# Ground Floor Plan

S4.55 COMPARISON

# Level 20 - Planning

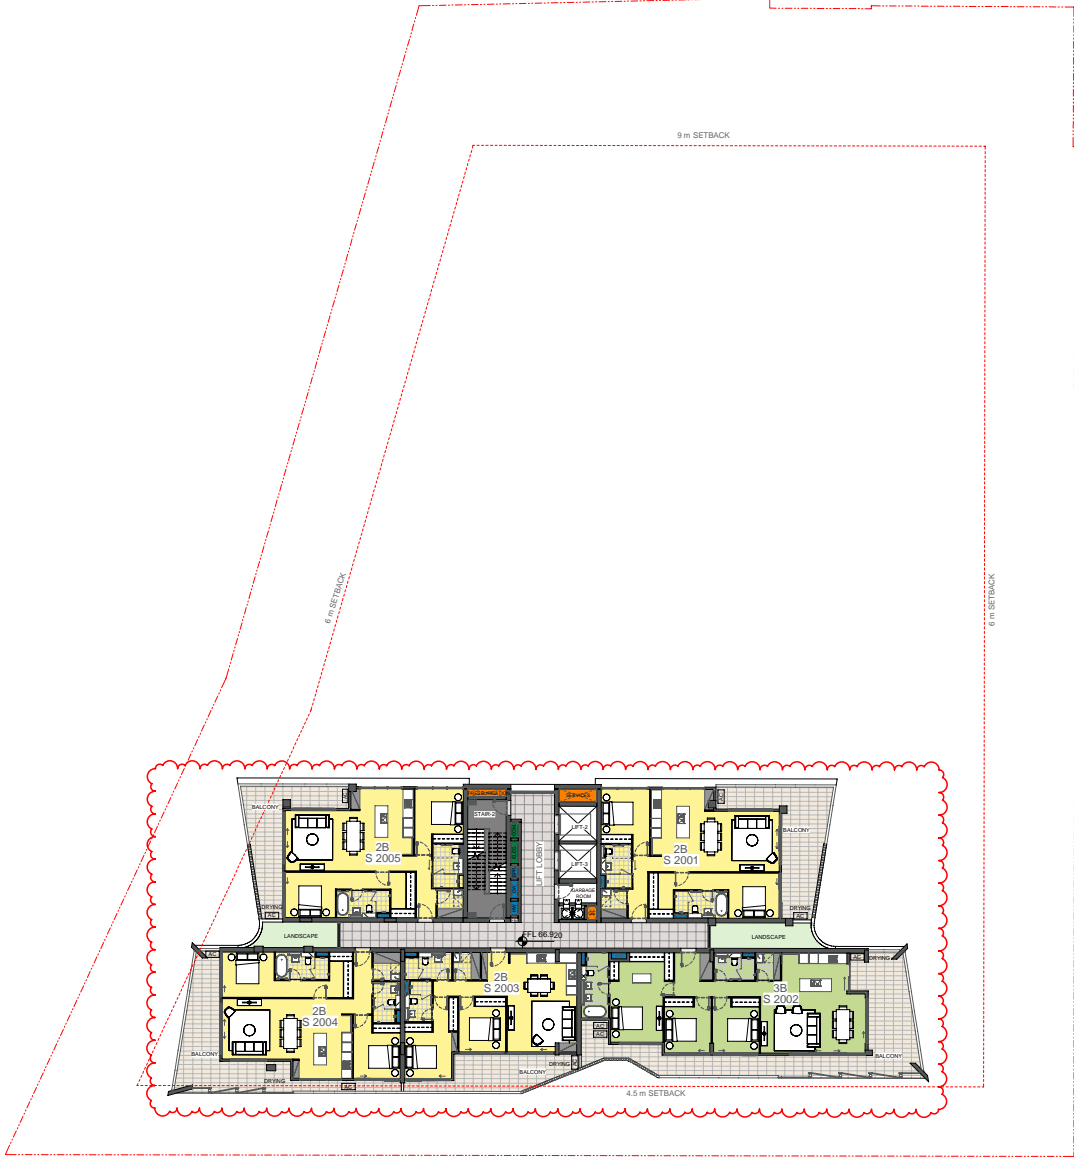
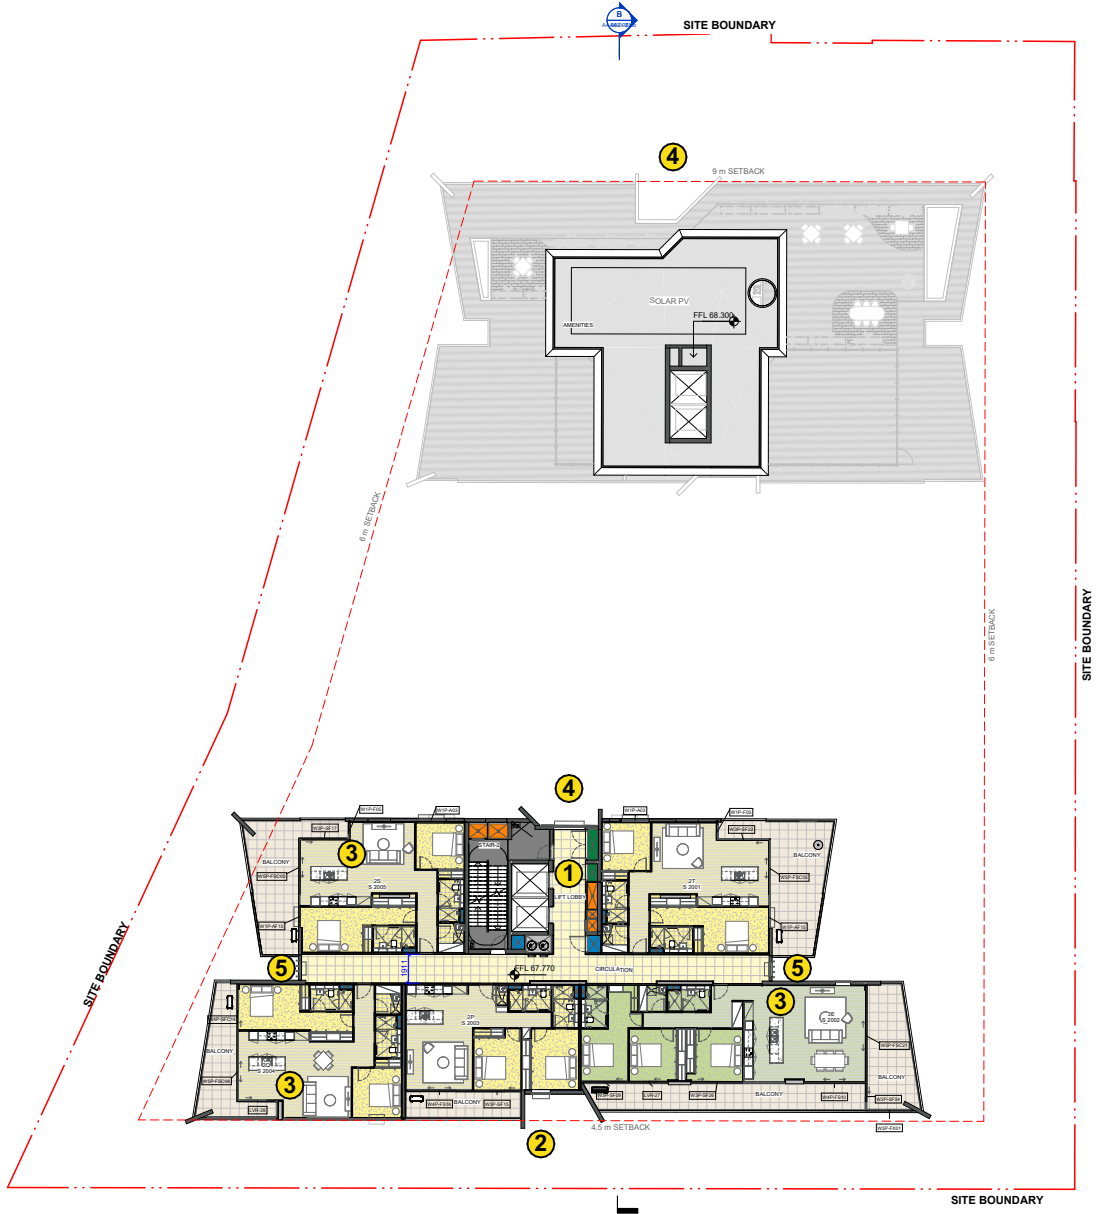
- 1. Lobbies changed - lift locations, consolidated with stair following structural input
  - 2. Setbacks to boundaries remain the same
  - 3. Minor alterations unit layouts and circulation
    - a) Minor planning changes to units generally including external footprint
  - 4. Minor alterations to tower geometry and construction detail
  - 5. Landscaping removed from buildings central axis
- Vertical external screens added.

# Roof - Planning

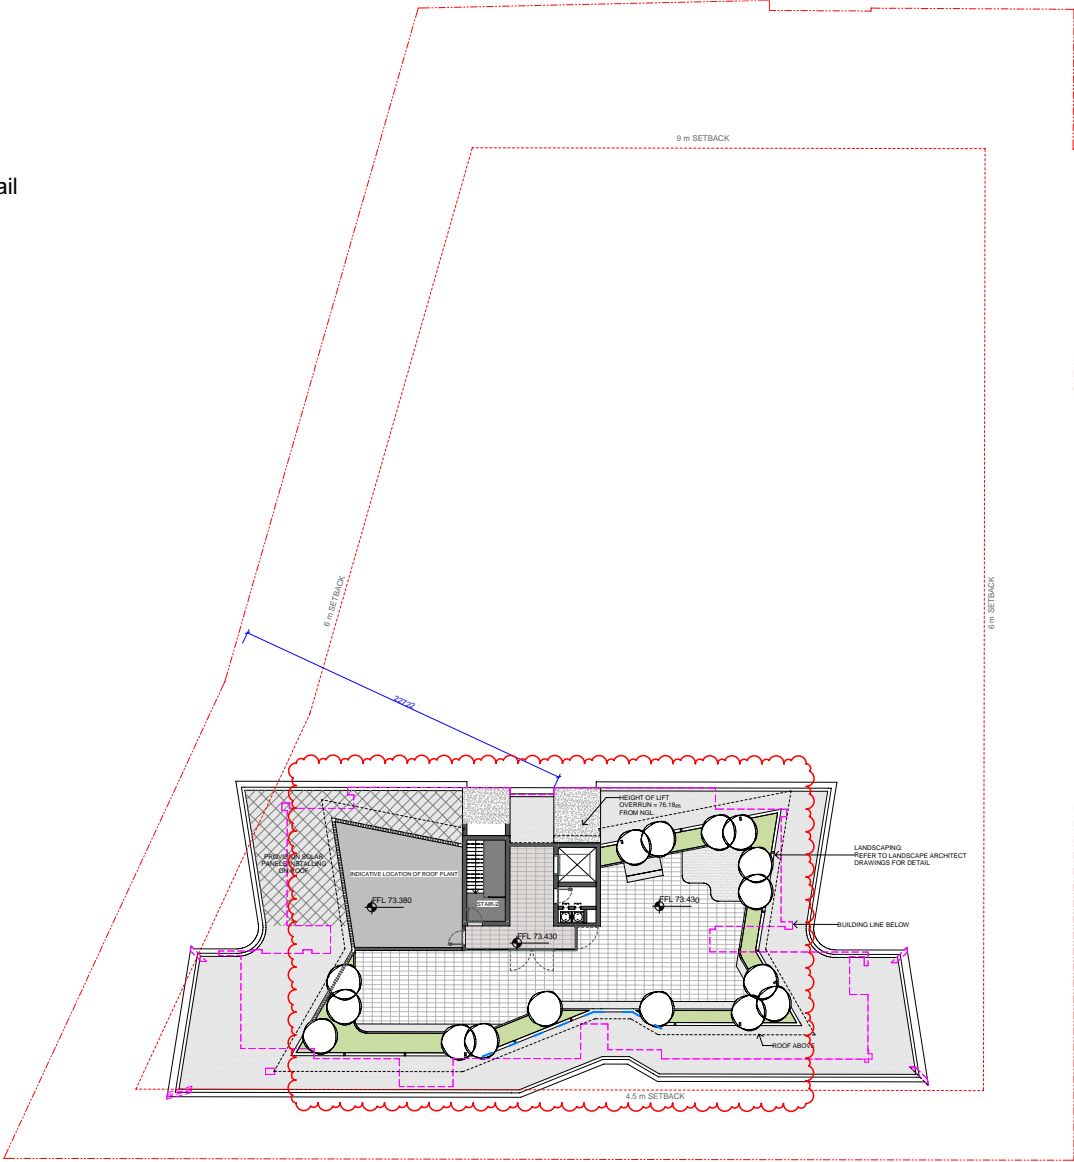
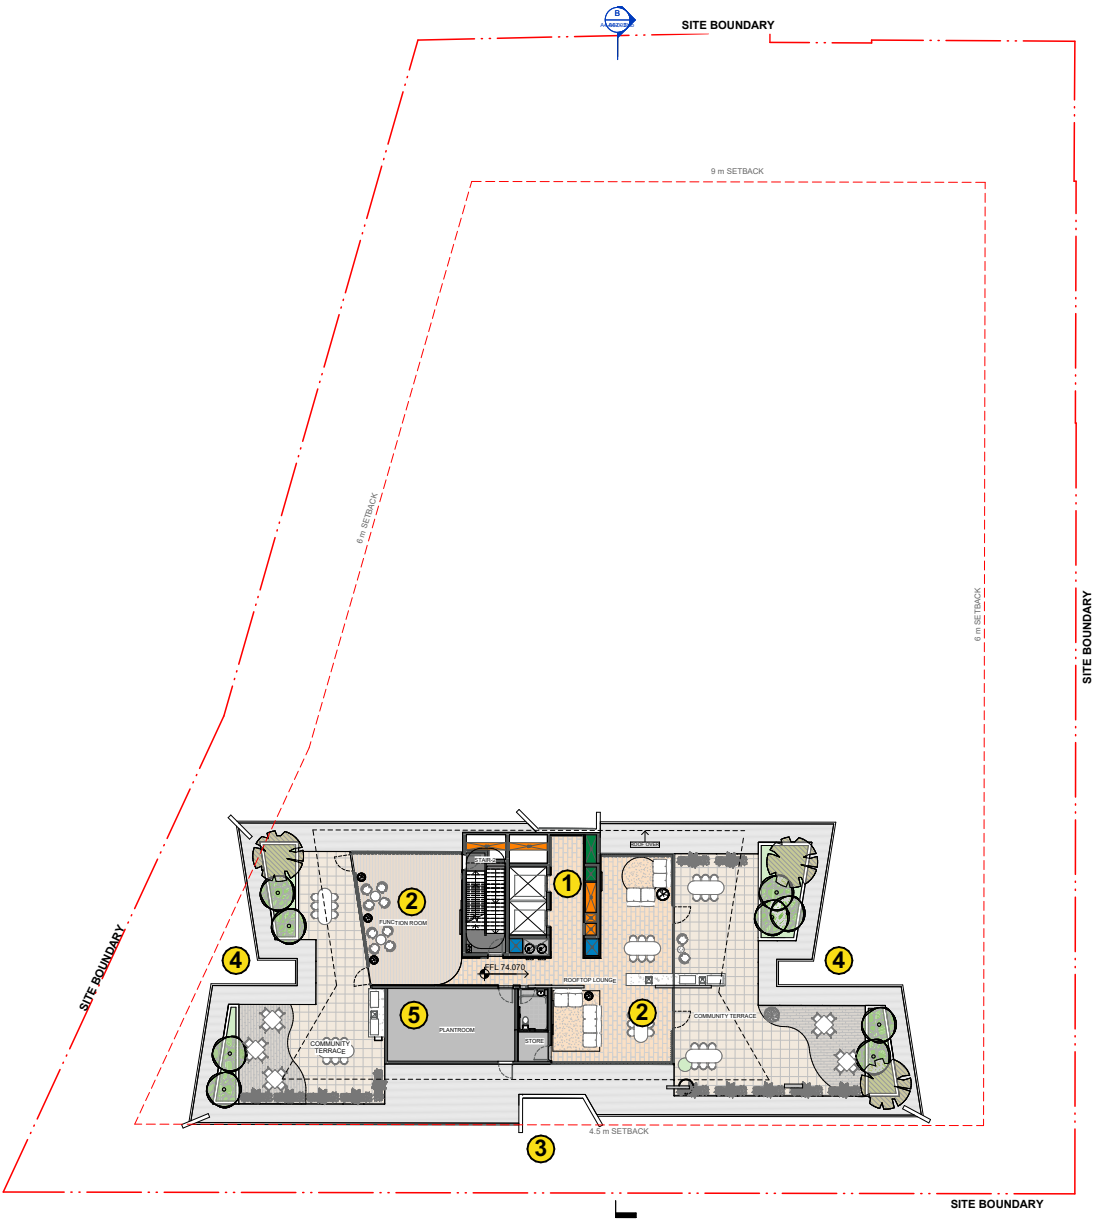
- 1. Lobbies changed - lift locations, consolidated with stair following structural input
- 2. South tower communal space increased and enhanced
- 3. Setbacks to boundaries remains the same
- 4. Minor alterations to tower geometry and construction detail
- 5. Plant service room location changed

# Elevation 01 - King St

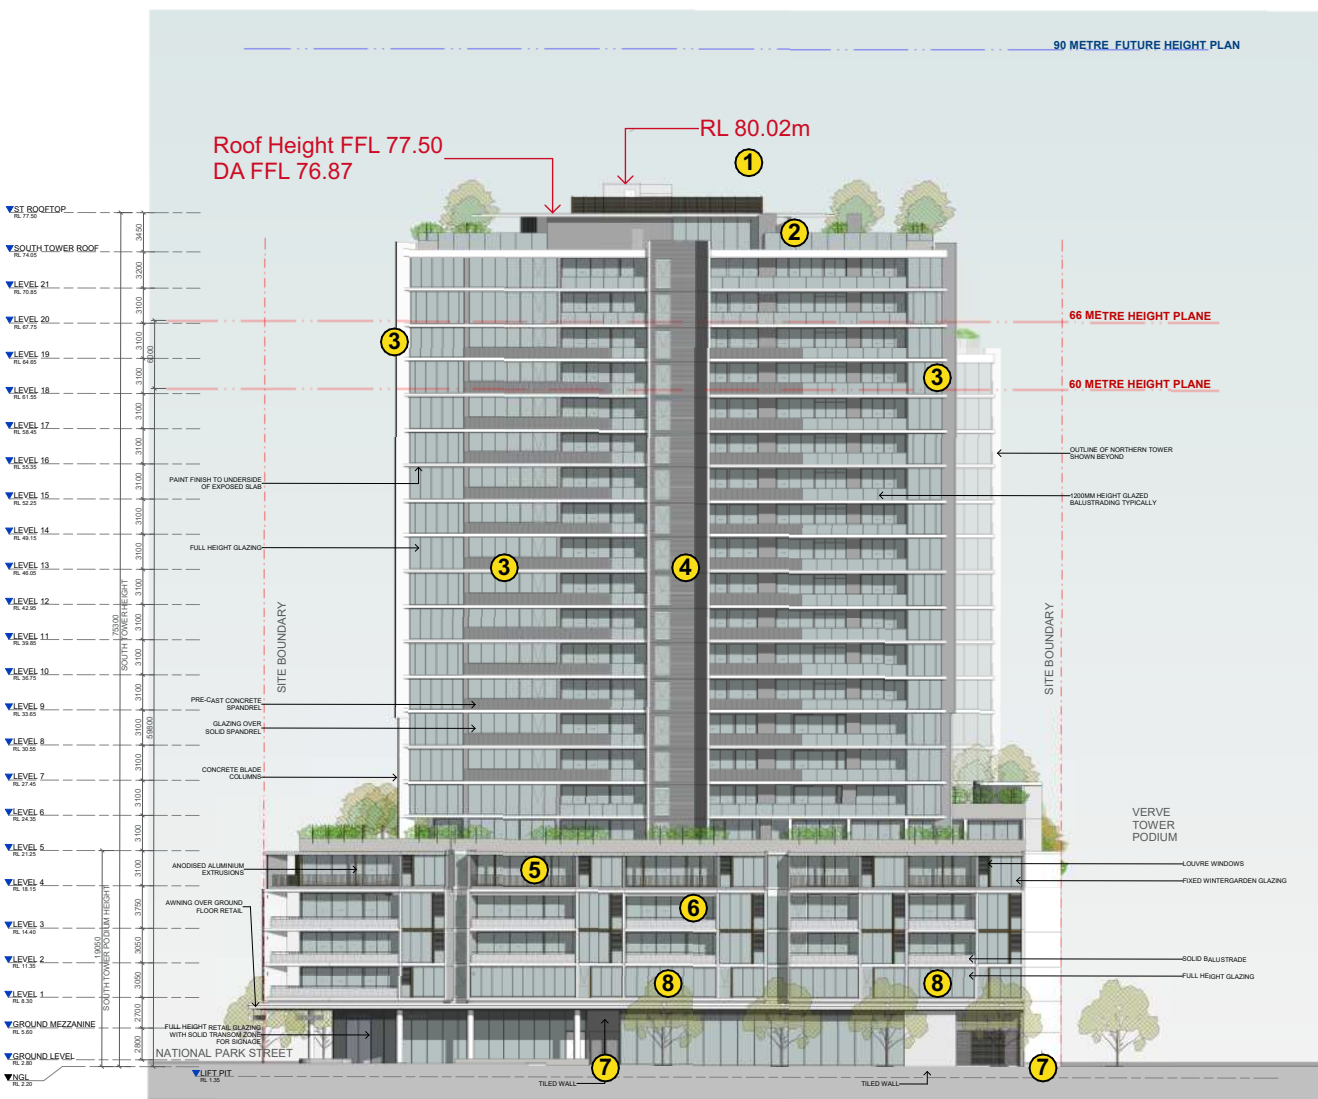
1. The height of the southern tower has increased marginally from 78.38m (top of lift overrun) in the approved DA to 80.02m in the amended DA. The actual roof level of the South tower has increased by just 630mm from FFL 76.87 TO 77.50.
2. Rooftop communal area on South building has been increased.
3. Reduce glazing / integrate the proposed pre-cast panels in the tower facades. The architectural language uses vertical blades and columns to create varied interest juxtaposing the horizontal language of the balustrades and slab edges.
4. A central pre-cast slot has been introduced to articulate the tower forms and address councils request for reduction of horizontal design language on the tower.

5. Podium - The podium has been re-evaluated to align with preferred building methodologies reflecting the current economic climate. Anodised aluminium feature columns on the balconies are proposed and the design simplified.
6. Solid balustrades to podium levels have been introduced along with enclosed sections of glazing to improve resident amenity and address noise and privacy issues, particularly along King Street.
7. Increase to substation along King Street. Tiled wall proposed to address substation requirements. Louvre screens similar to Verve proposed for the substation.
8. Enclosure of commercial balcony areas on Level 1 to increase overall commercial floor area.

# Elevation 02 - National Park St

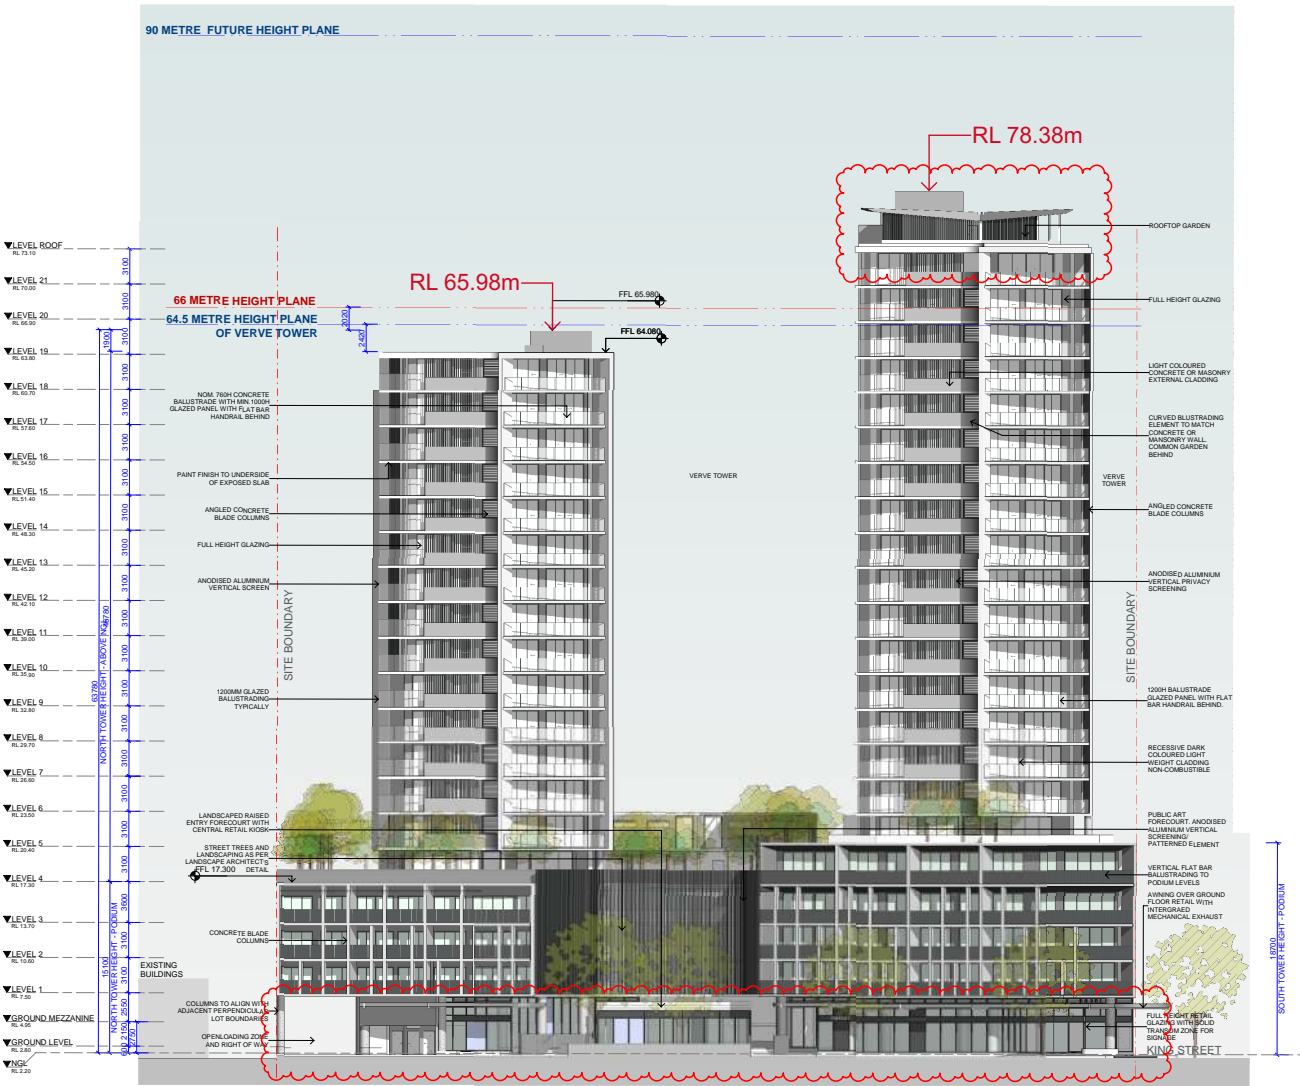
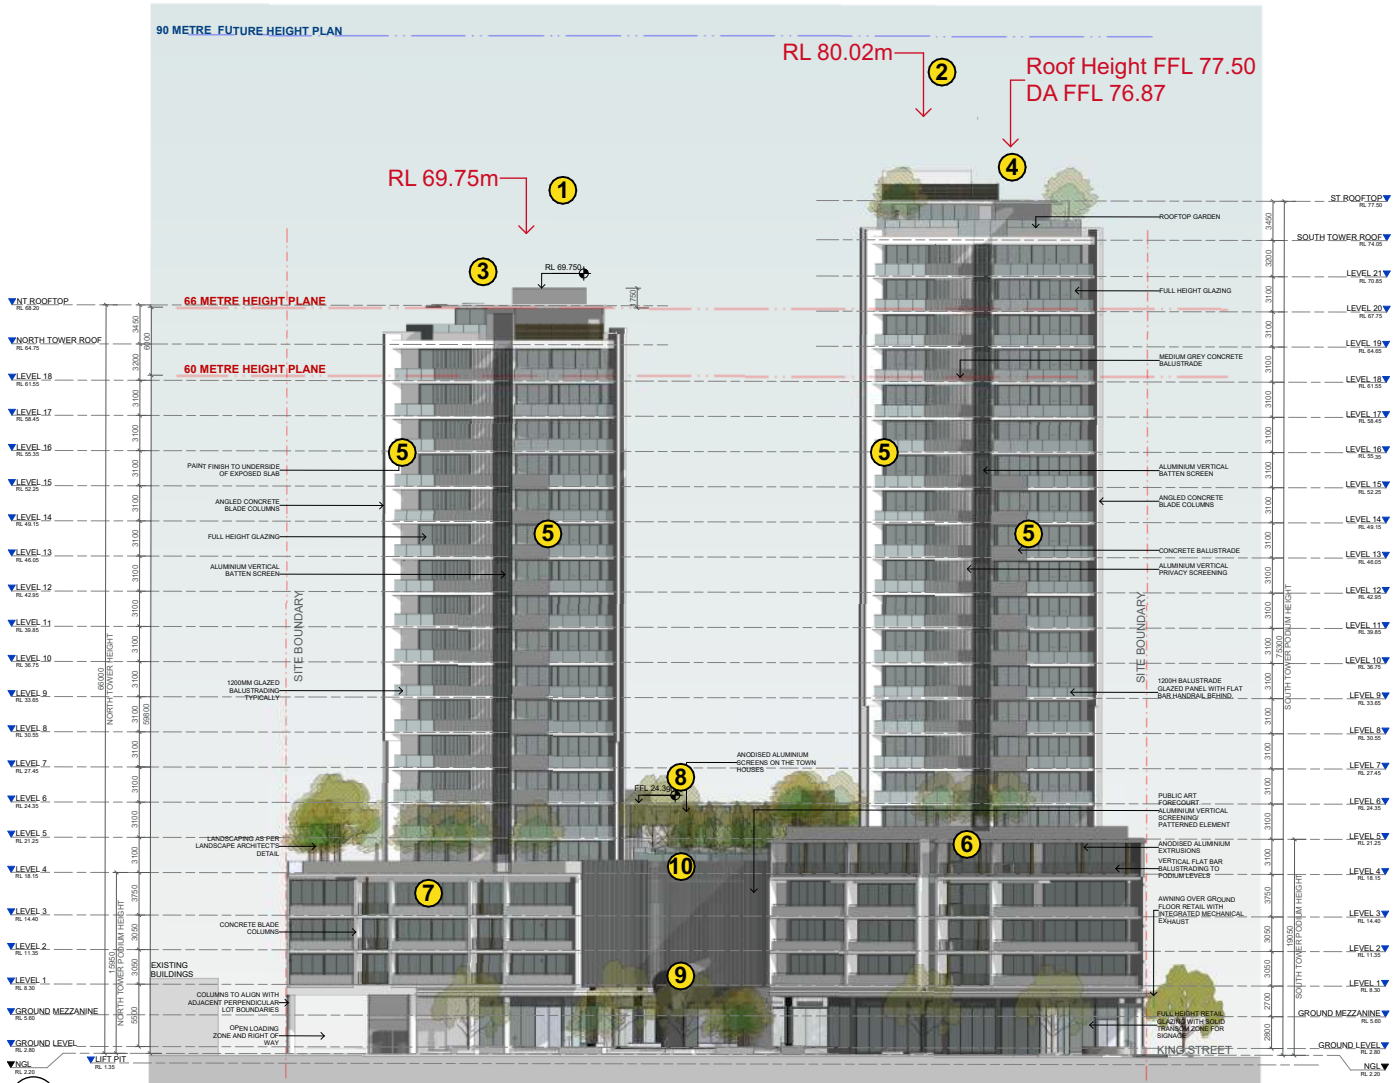
1. The height of the northern tower has increased from 65.98m (top of lift overrun) in the approved DA to 69.75m in the amended DA. An increase of 3.77m.

2. The height of the southern tower has increased marginally from 78.38m (top of lift overrun) in the approved DA to 80.02m in the amended DA. The actual roof level of the South tower has increased by just 630mm from FFL 76.87 TO 77.50.

3. The entire top floor of the Northern tower has now been dedicated entirely to communal functions.
4. Rooftop communal area on South building has increased.

5. Reduce glazing / integrate the proposed pre-cast panels in the tower facades. The architectural language uses vertical blades and columns to create varied interest juxtaposing the horizontal language of the balustrades and slab edges. Vertical screens added to the East and West elevations to enhance the vertical architectural language in lieu of landscape planting to end of corridors.

6. Podium - The podium has been re-evaluated to align with preferred building methodologies reflecting the current economic climate. Anodised aluminium feature columns on the balconies have been proposed and the design simplified.
7. Solid balustrades to podium levels have been introduced along with enclosed sections of glazing to improve resident amenity and address noise and privacy issues, particularly along King Street.
8. Enhance communal spaces with better amenity, including pool and podium.
9. Improved access and amenity to forecourt. Increased landscaping and outdoor seating.
10. Width of Forecourt Screening at upper podium levels has decreased due to revised unit planning. Forecourt Screening to be integrated into the Public Art Proposal.
